AMENDMENT NO. 3 MARCH 2000
TO
IS 897 : 1982 SPECIFICATION FOR TUNGSTEN
FILAMENT ELECTRIC LAMPS FOR RAILWAY
ROLLING STOCK

(*Second Revision*)

FIG. 3 DIMENSION OF LAMPS 32 V, 250 W

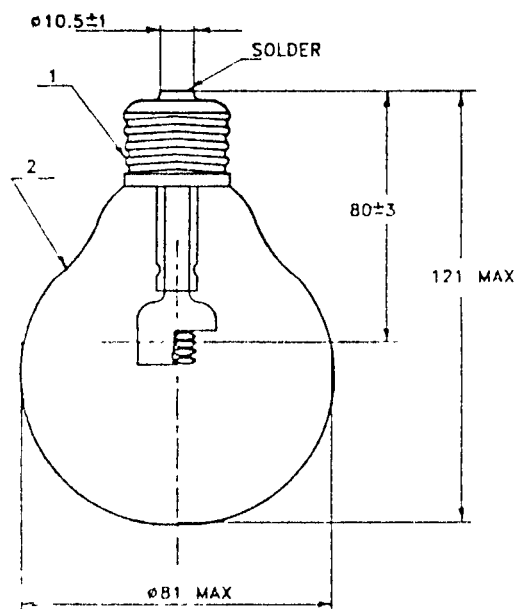
(Page 6, Table 2, see also Amendment No. 1) — Substitute the following for the existing:

Table 2 Dimensions of Lamps
(Clause 4.1.2, and Fig. 3 to 5)

Rated Voltage	Rated Wattage	Light Centre Length	Maximum bulb Diameter	Maximum Overall Length* Including Solder	Figure Reference Number
(1) V	(2) W	(3) mm	(4) mm	(5) mm	(6)
24/32	15	Actual	46	70 $\pm$ 2	
	20	overall	46	70 $\pm$ 2	
	30	length -1/2 bulb diameter	46	70 $\pm$ 2	
32	250	80 $\pm$ 3	81	121	3
75	25	—	53	72	4
	50	—	61	110	5
	15	—	30	62	4
110/ 120	25	—	61	103.5	4
	40	—	61	110	5
	60	—	61	110	5
	100	95 $\pm$ 2	71	121	—
* When screw cap E-27/27 is used, the maximum overall length may be correspondingly increased.
